APRIL 6, 2022
SUBMITTALS

2021-COA-613 (SJ)
244 E. 10TH ST.

Gregor Residence - Design Review

IHPC STAFF REPORT (FROM 02 FEBRUARY 2022 HEARING) &
ARCHITECT RESPONSES

ORIGINAL CONCEPT IMAGE (PRESENTED TO SJHN MEETING ON 09.07.2021 & IHPC STAFF MEETING ON 09.10.2021)

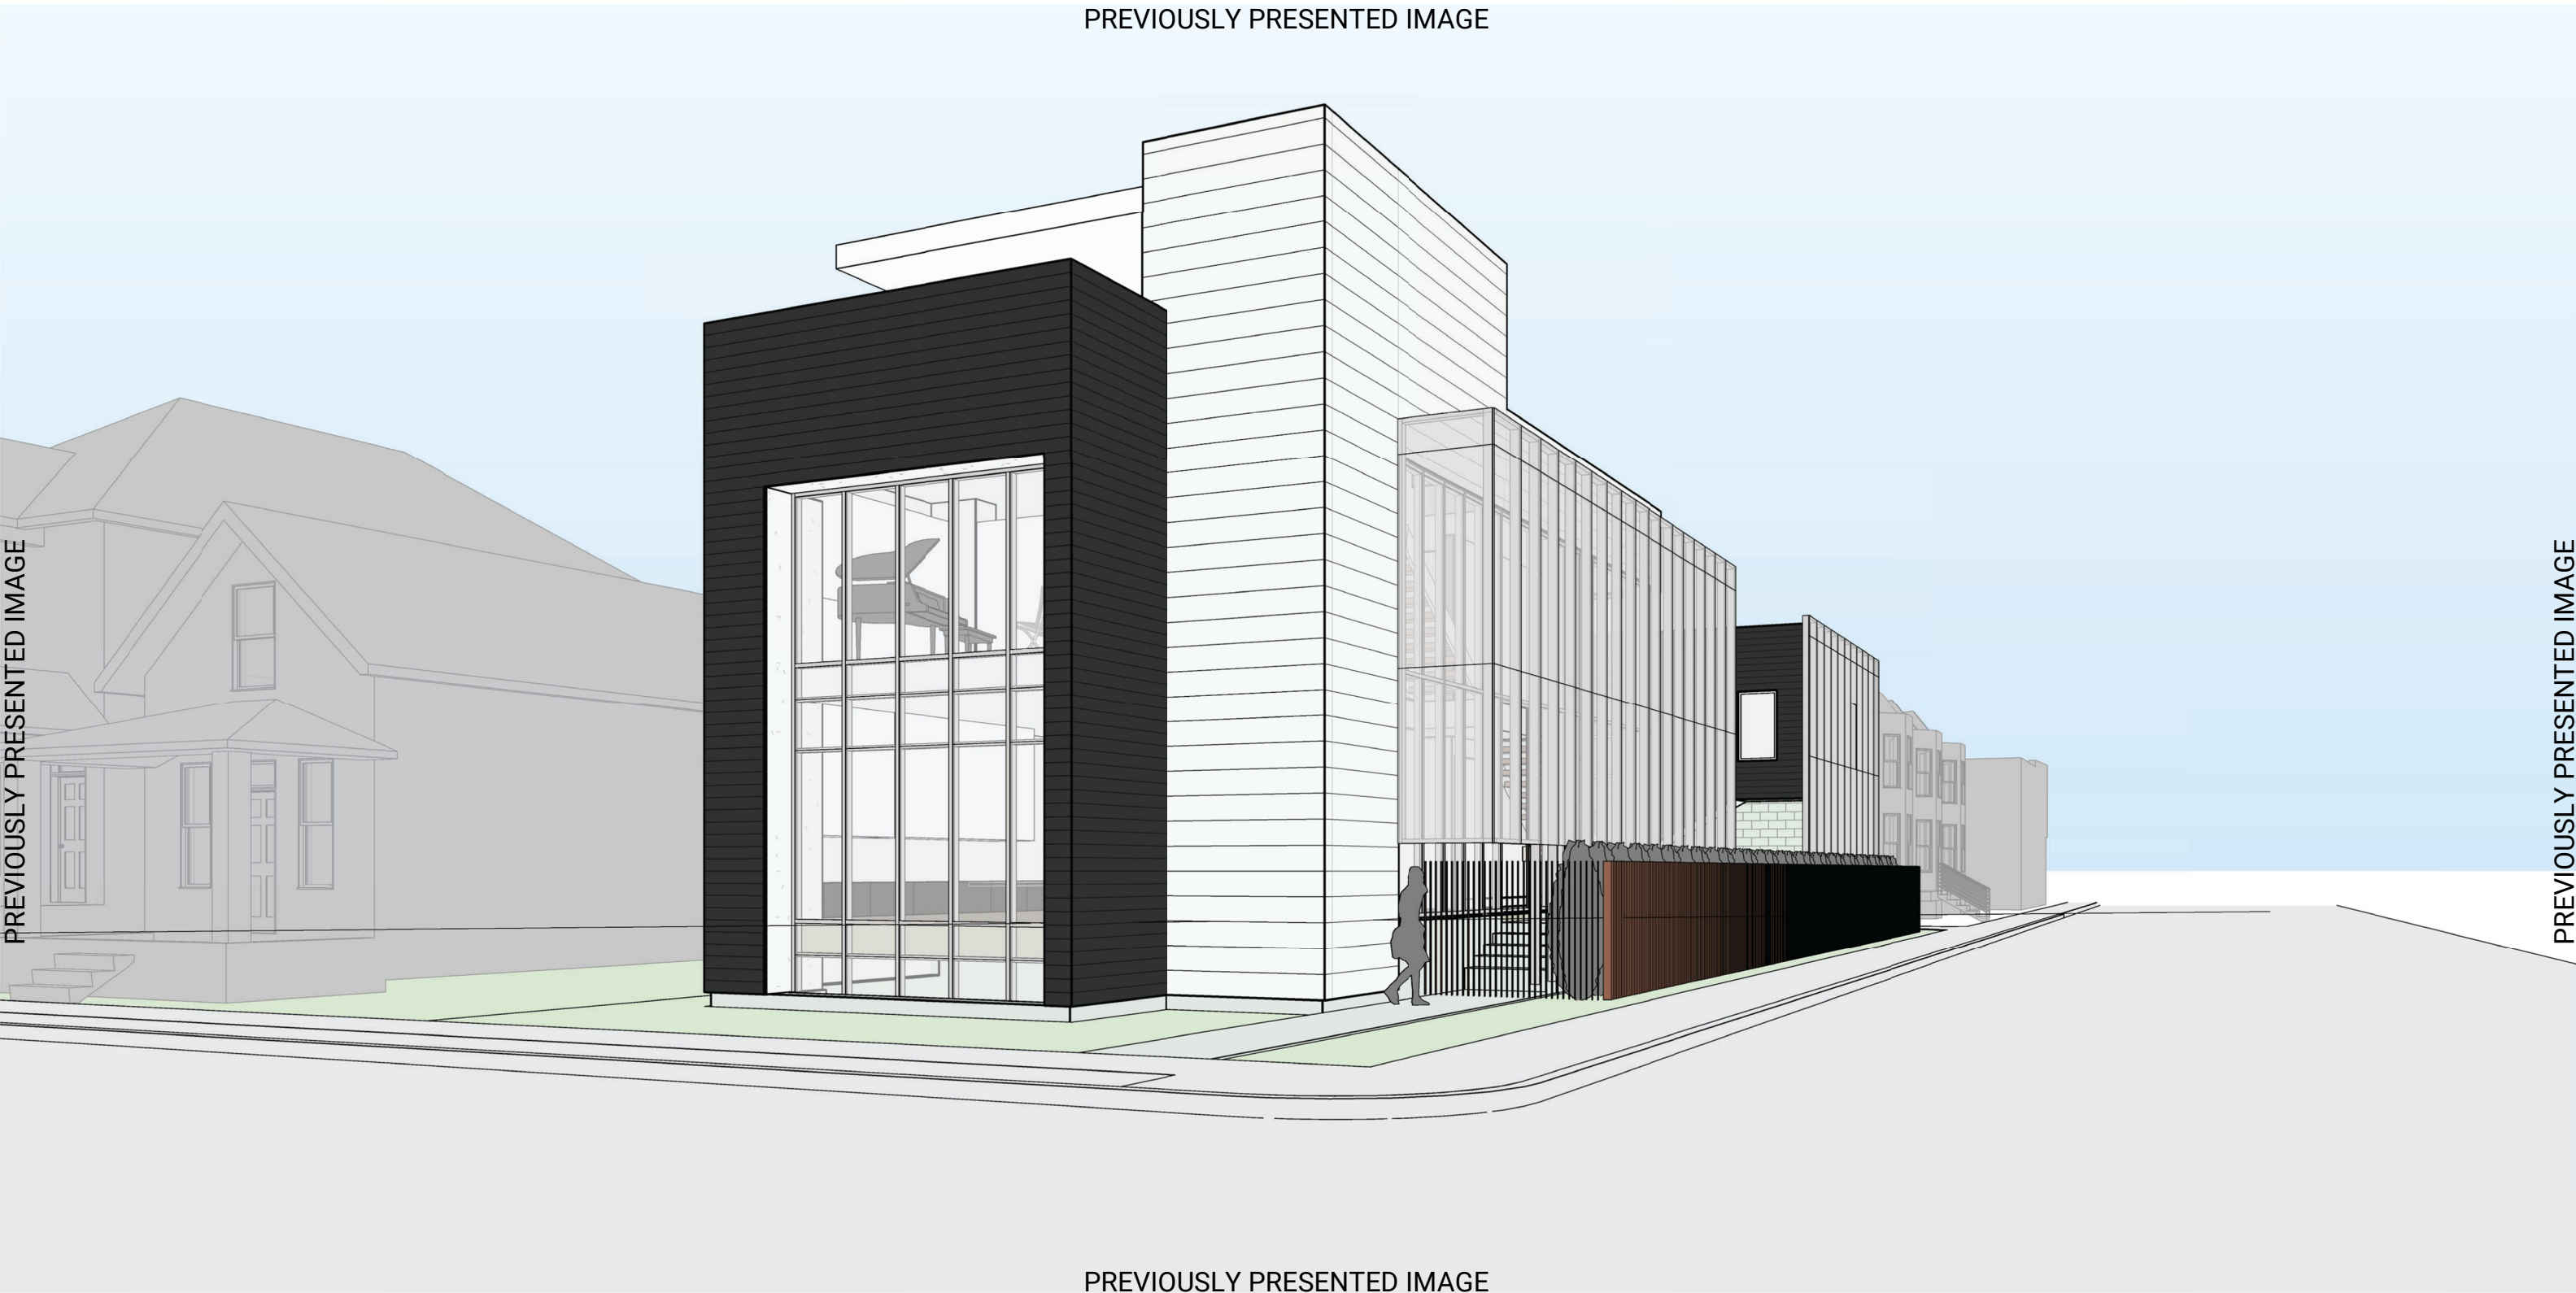
IHPC STAFF COMMENTS/CONCERNS FROM PREVIOUS ITERATION (09.10.2021)

- VERY CONTEMPORARY DESIGN WOULD BE BETTER SUITED FOR A DIFFERENT LOCATION
- PROPOSED MATERIALS ARE TOO CONTEMPORARY
- SETBACK - STRUCTURE SHOULD BE MORE IN LINE WITH HOUSES TO THE WEST

- BUILDING HEIGHT - PROPOSED HOUSE IS TOO TALL. BROUGHT DOWN SOMEWHERE BETWEEN HISTORIC COTTAGE AND 2-STORY HOUSE
- COMMISSION WILL NOT APPROVE 2 STORY CONNECTOR

- BUILDING OUTLINE - OUTLINE OF PROPOSED HOUSE DOES NOT REFLECT THE SHAPE OF NEIGHBORHOOD CONTEXT. ADD HIPPED AND/OR GABLE ROOFS
- FENESTRATION - CURTAIN WALLS DO NOT REFLECT OR COMPLEMENT HISTORIC/TRADITIONAL FENESTRATION PATTERNS

- ENTRY - THE FRONT DOOR IS HIDDEN
- FENCING - 6 FOOT FENCE IS NOT PERMITTED FOR CORNER LOT. FENCE DESIGN ALSO NOT CONSIDERED APPROPRIATE BY ST. JOSEPH HISTORIC AREA PLAN

- CLEAR-SIGHT-TRIANGLE - PRIMARY ARTERIALS REQUIRE 120' LINE OF SIGHT, LOCAL STREETS REQUIRE 75' LINE OF SIGHT.
 - WALL OF 7' TREES
 - TYPE OF PLANTING NOT CONSISTENT WITH LANDSCAPING ALONG STREETS IN DISTRICT

- FURTHER IMPEDE PEDESTRIAN AND VEHICULAR TRAFFIC VISIBILITY AT INTERSECTION

NEIGHBORHOOD COMMENTS/CONCERNS FROM PREVIOUS ITERATION (09.07.2021)

- PRIVACY FENCE MATERIAL/HEIGHT
- OVERALL MASS
- INCONSISTENT BUILDING MATERIALS
- SENSE OF ENTRY TO THE HOUSE

DESIGN CHANGES IMPLEMENTED SINCE PREVIOUS ITERATION

- INCORPORATION OF BRICK VENEER INTO MATERIAL PALETTE TO REPLACE LARGE EXPOSURE WHITE SIDING
- SOUTH FACADE ALIGNED WITH ADJACENT BUILDING
- LOWERED SOUTH FACADE HEIGHT
- LOWERED GARAGE MASS HEIGHT
- LOWERED BRISE SOLEIL HEIGHT
- OPENINGS IN BRISE SOLEIL UTILIZED TO RELATE TO SURROUNDING BUILDING FENESTRATION PATTERNS
- INCREASED AREA OF SOLID WITHIN SOUTH ELEVATION CURTAIN WALL
- ACCENTUATED FOUNDATION/WATERTABLE LINE
- DECREASED AREA OF CURTAIN WALL FACING ALABAMA STREET
- EXPLORED "FRONT PORCH" TO INCREASE HORIZONTAL CONNECTIONS TO ADJACENT BUILDINGS

HISTORIC LOT COVERAGE PROPOSED LOT COVERAGE

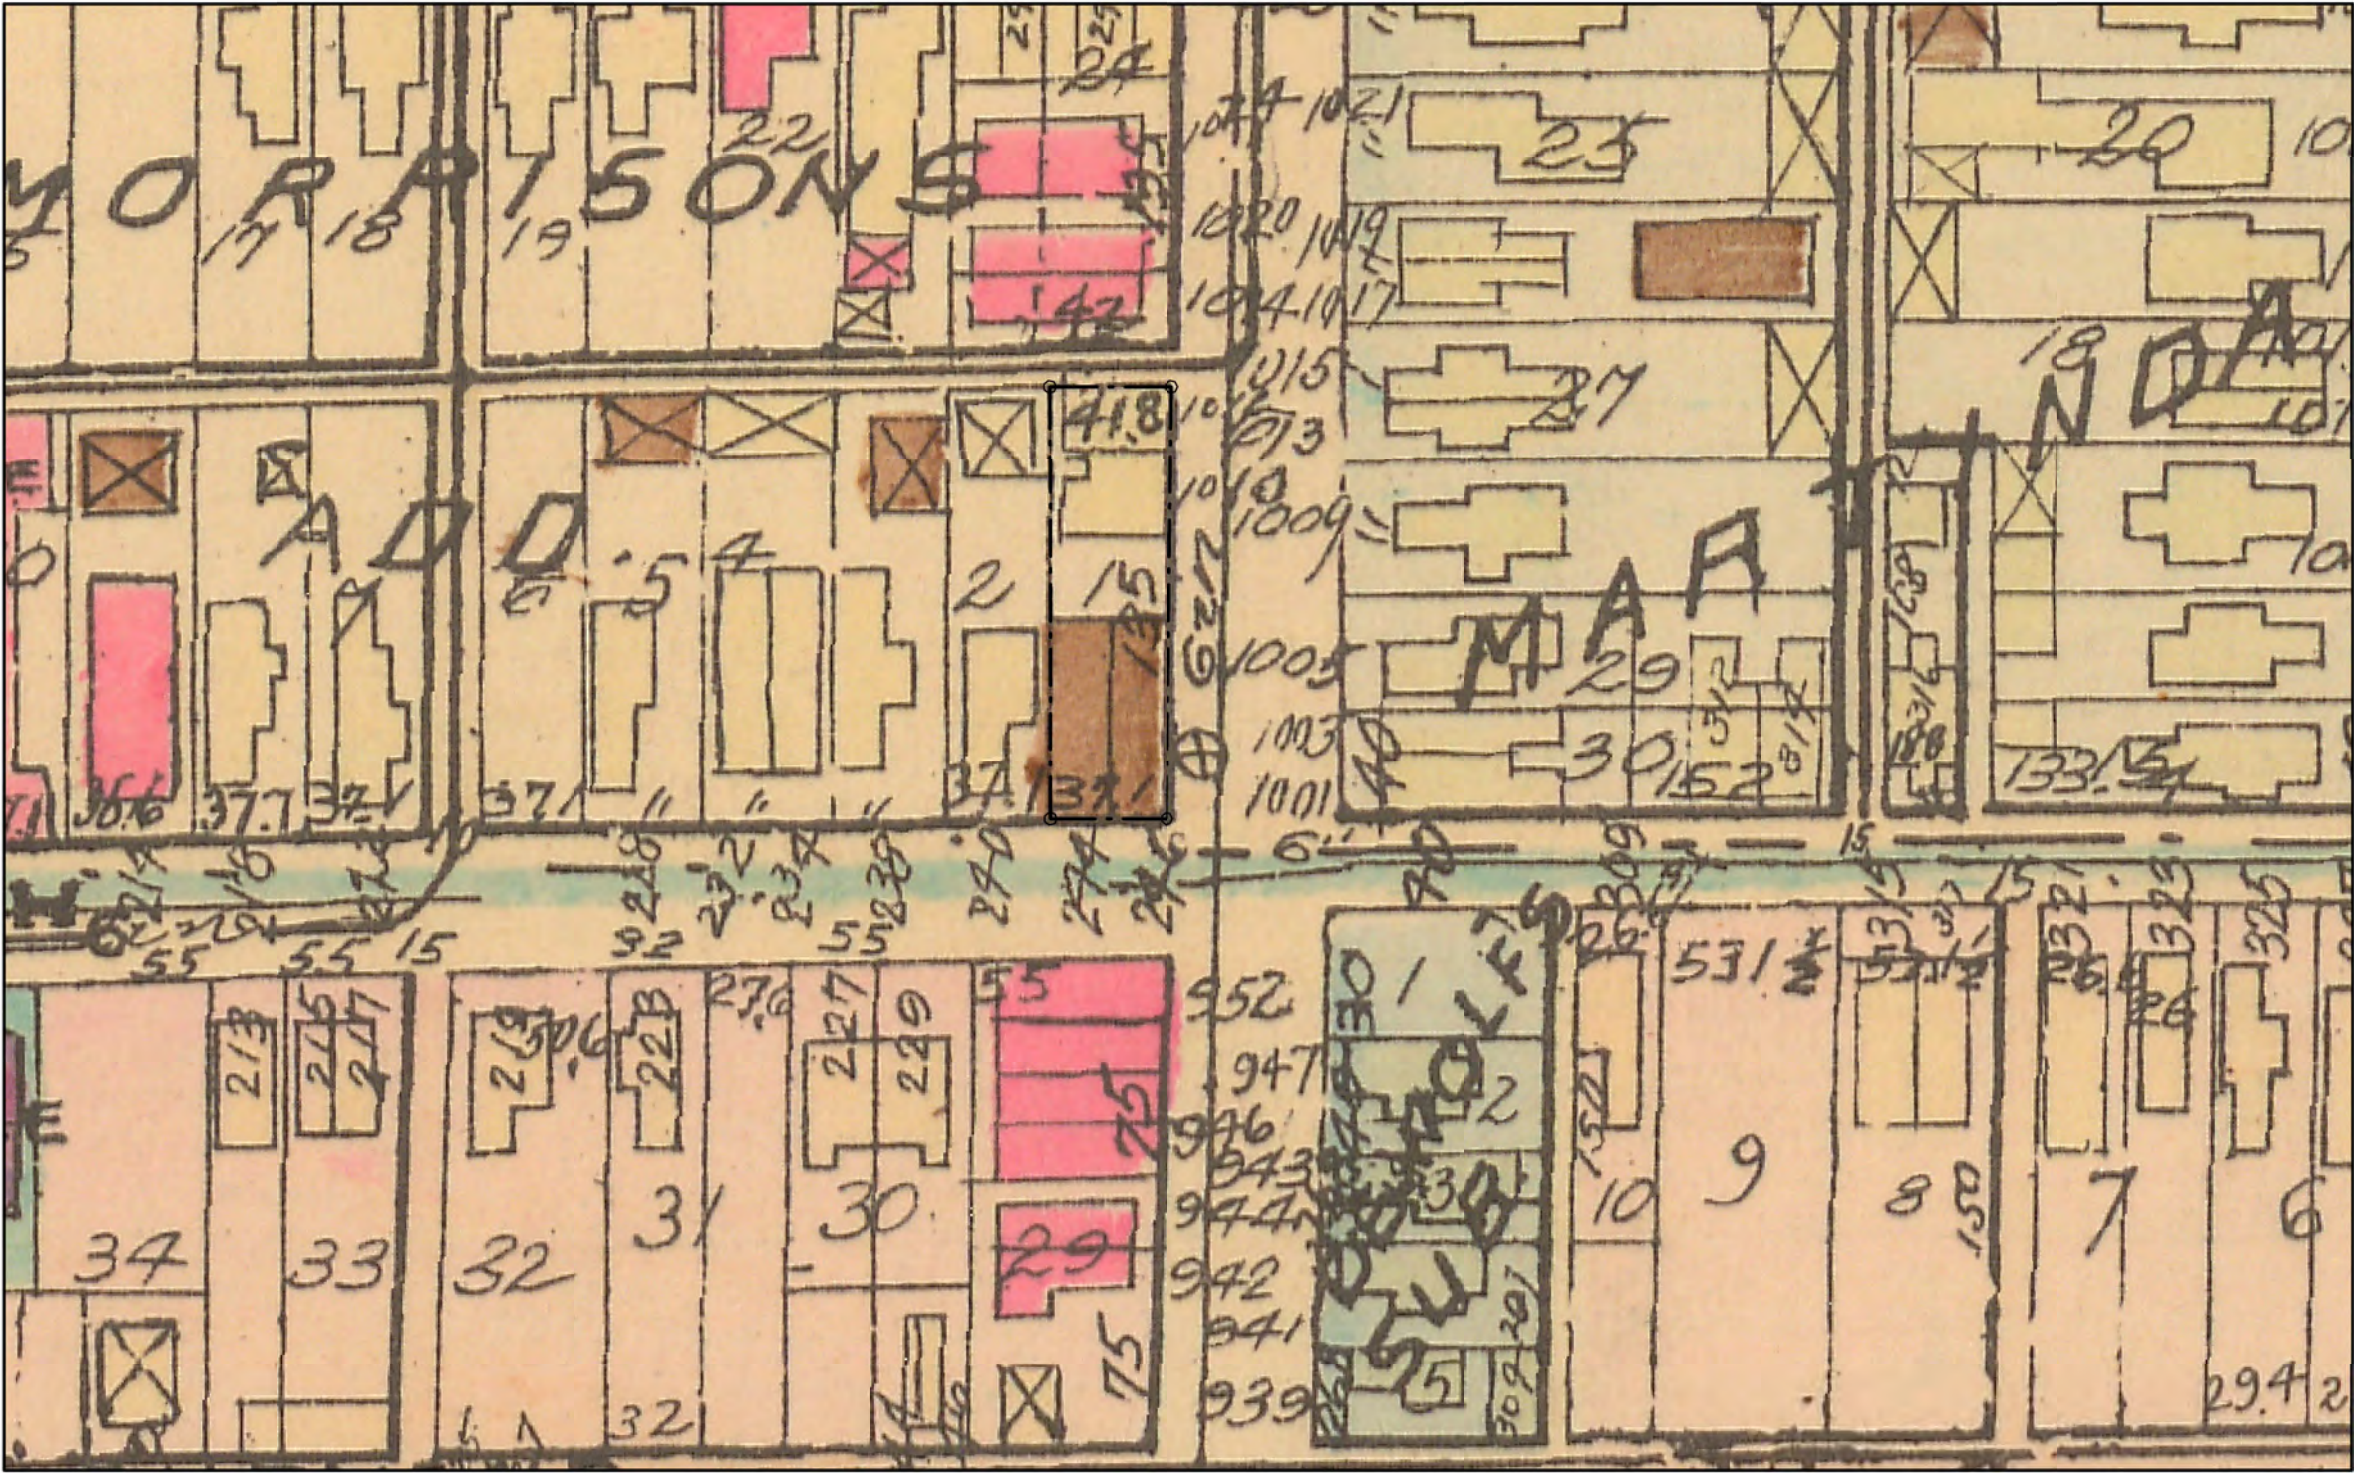
The neighborhood would like to see the 40/70 clear sight triangle on this east side of the alley. There is not clear sight on the west side of the alley. Exiting to the west is nearly impossible. Use of the alley, and a safe exit on the east side of it is important for all residents on 10th and 11th streets.

Accessible Roof IHPC Floor Plan

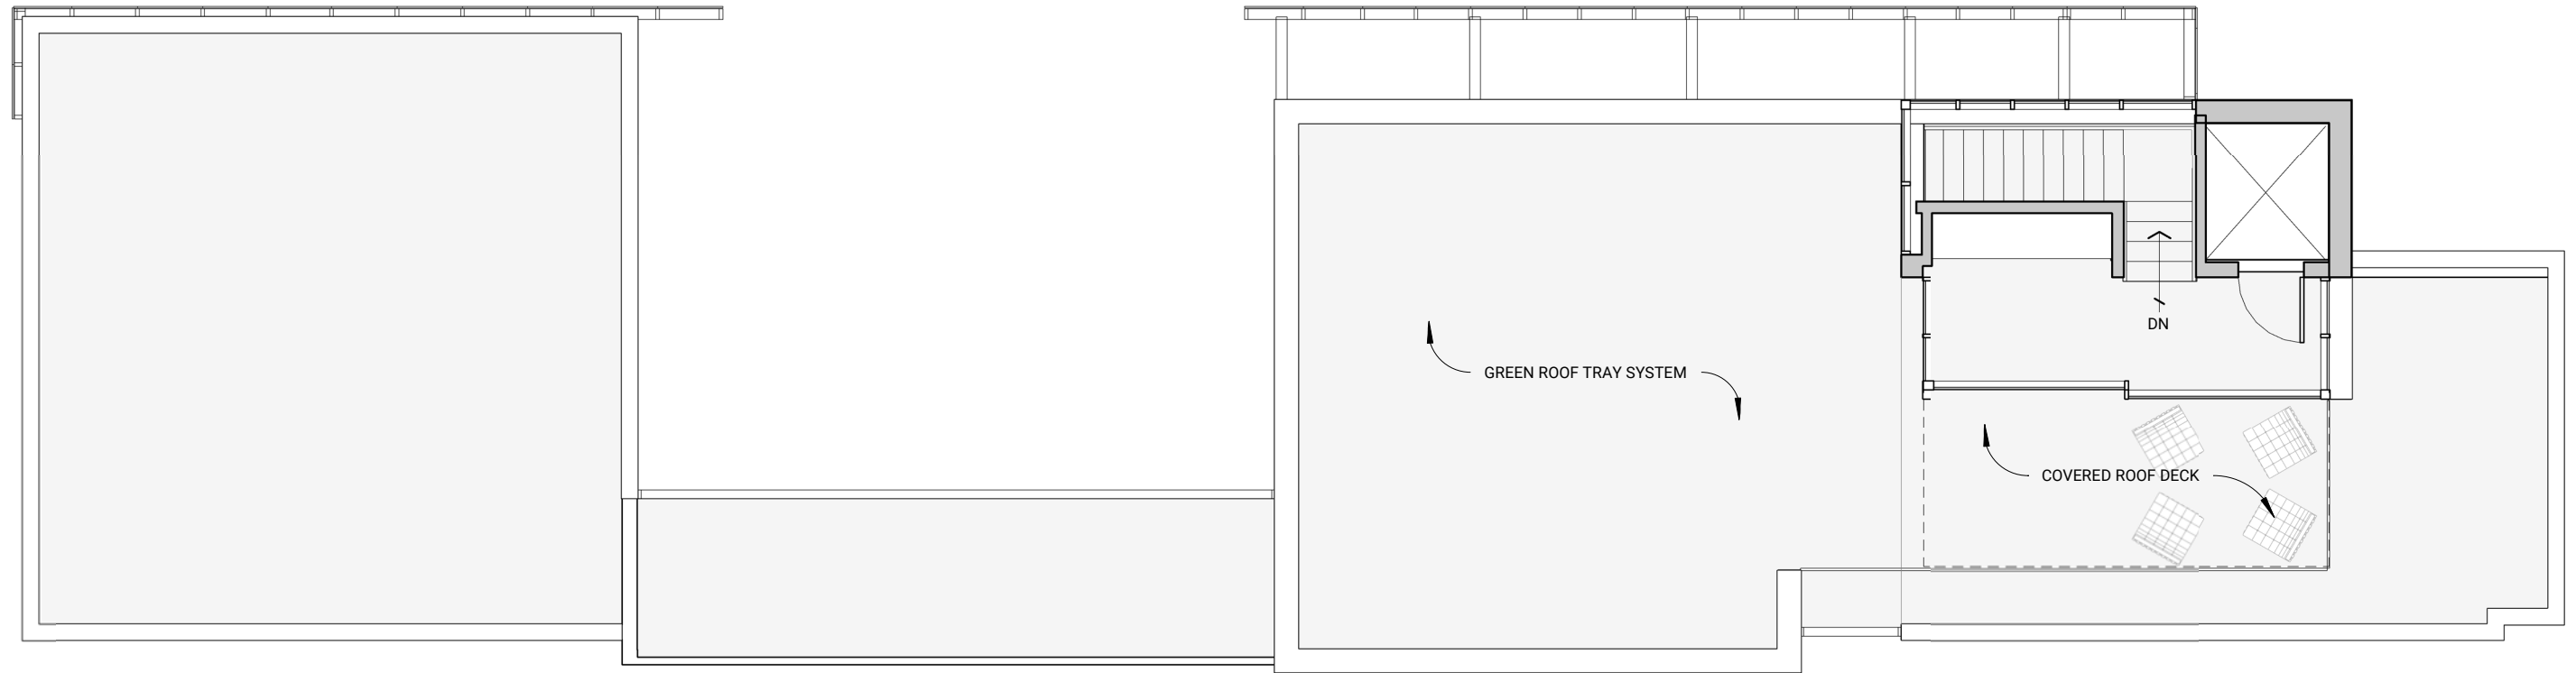
We still have a 2 story connector. This is inappropriate. Many in the neighborhood would like this structure to mimic the other houses on 10th street. There is only one house in the whole neighborhood with a connector and it is tucked away and not in such a prominent place.

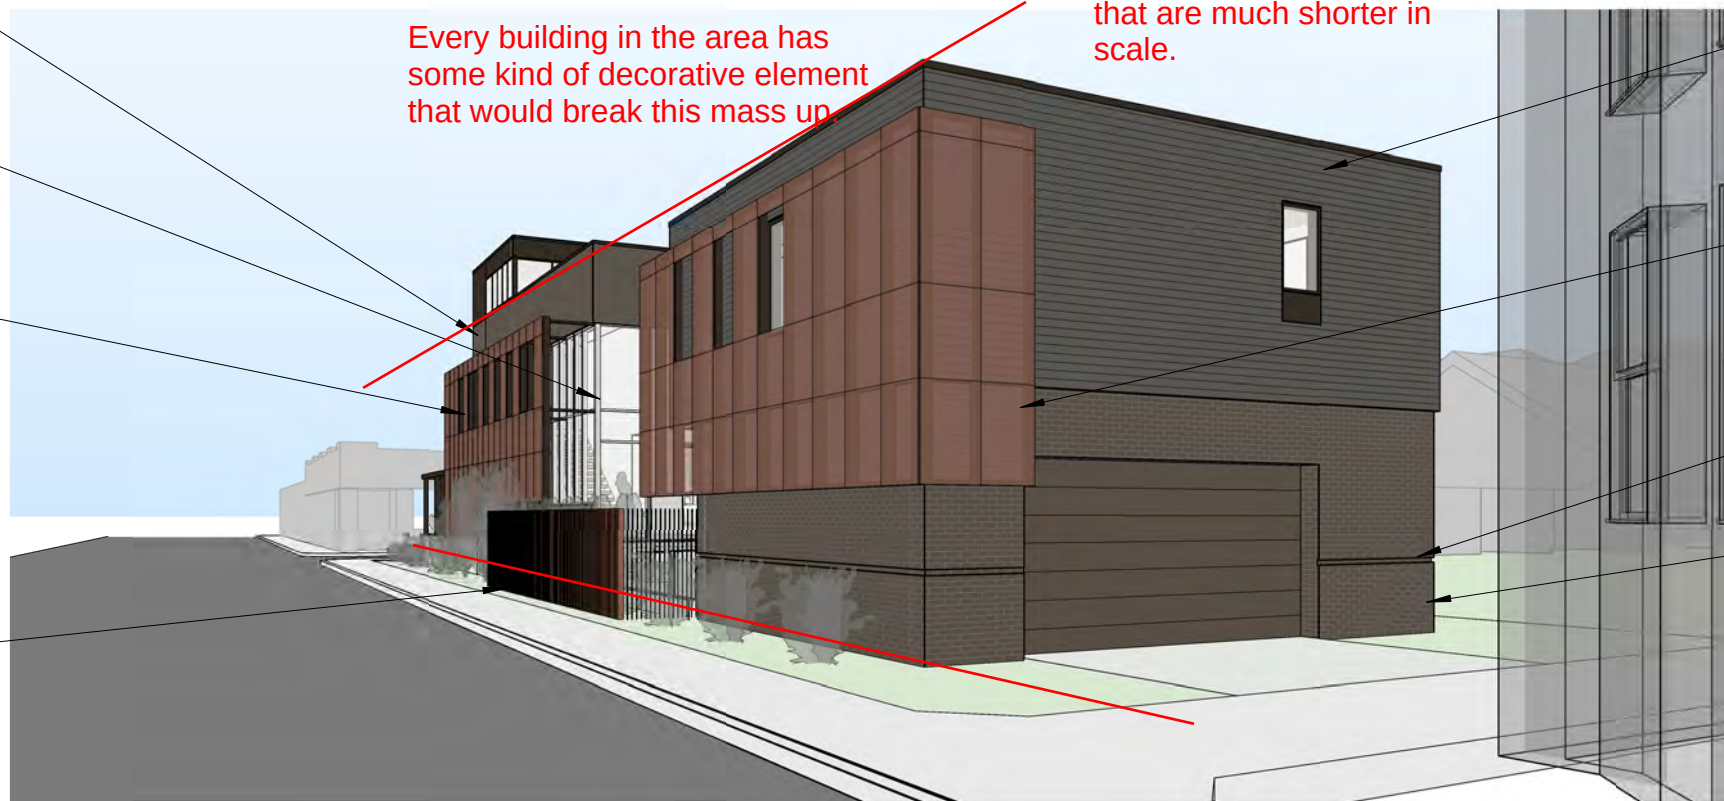
The steel fence wall is inappropriate material, too tall, too close to the side walk, and not an appropriate design for the neighborhood.

Every building in the area has some kind of decorative element that would break this mass up.

All the flat roofs in the area are on buildings that are much shorter in scale.

6" WIDE WOOD SIDING (BEHIND BRISE SOLEIL), PAINTED
03 This material is appropriate.
